## INSTRUCTION TO SERVICE

<b>ITS: 5328</b>	
<b>SECTION:</b>	420 Body AP EXT
<b>WRITTEN BY:</b>	Troy Stutsky
<b>SUBJECT:</b>	Add Wiper Relay Module

# ITS5328

**Figure 1: Wiper Switch Harness Connectors P4 and P6**

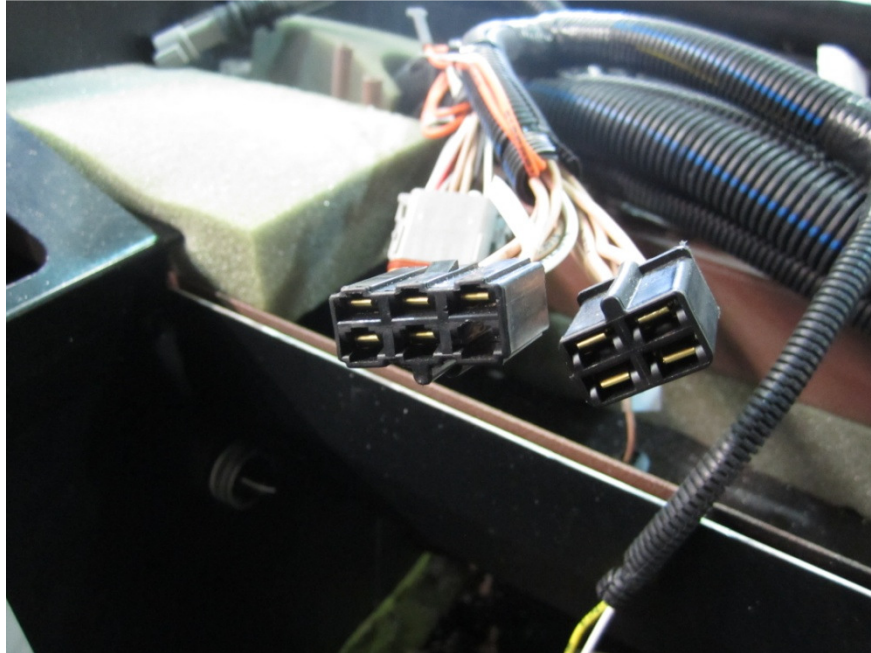
1. Turn the main battery disconnect switch to the “OFF” position.
2. Remove the dash panel.
3. Locate the wiper switch harness connectors P4 and P6. See Figure 1.
4. Unplug the connectors from the dash harness.

7. Plug wiper switch harness connectors P4 and P6 into wiper relay module.
8. Plug other end of relay module into dash harness that wiper switch harness connectors used to be plugged into.
9. Re-install dash panel.
10. Turn the main battery disconnect switch to the "ON" position.
11. Run test to make sure wipers are working correctly. Repair as required.
12. Remove all tools and debris from the bus and return to service.

**Figure 2: Wiper Relay Module and Bracket Fastened to Dash Panel**

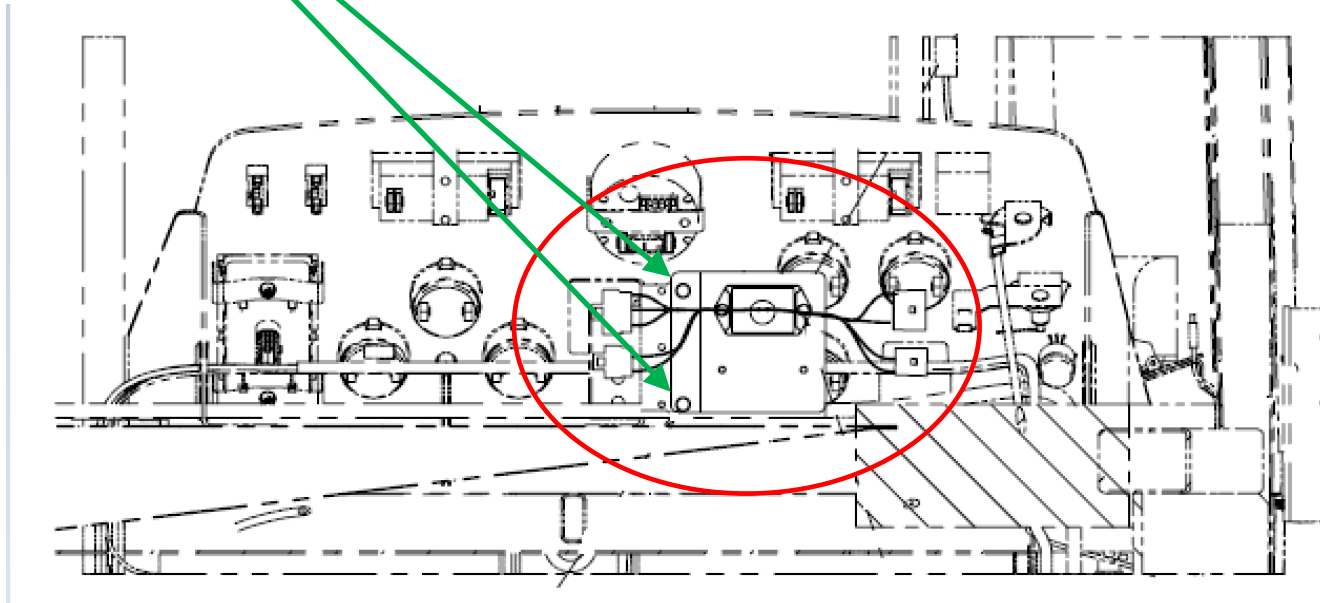
5. Fasten wiper relay module (PN 502757) to bracket (PN 502531) using qty two machine screws #8 x 3/4 (PN 14S98012), qty four #8 flat washers (PN 50W98000) and qty two #8 nylon lock nuts (PN 40N98000).
6. Take wiper relay module and bracket and fasten to existing holes in dash panel using qty two machine screw #10 x 1/2 (PN 14S00008) and qty two #10 washer (PN 50W00000). See Figure 2.

**NOTE:** Apply 1 to 2 drops of Loctite – 242 (PN 8110440) to end of #10 x 1/2 screws (PN 14S00008)
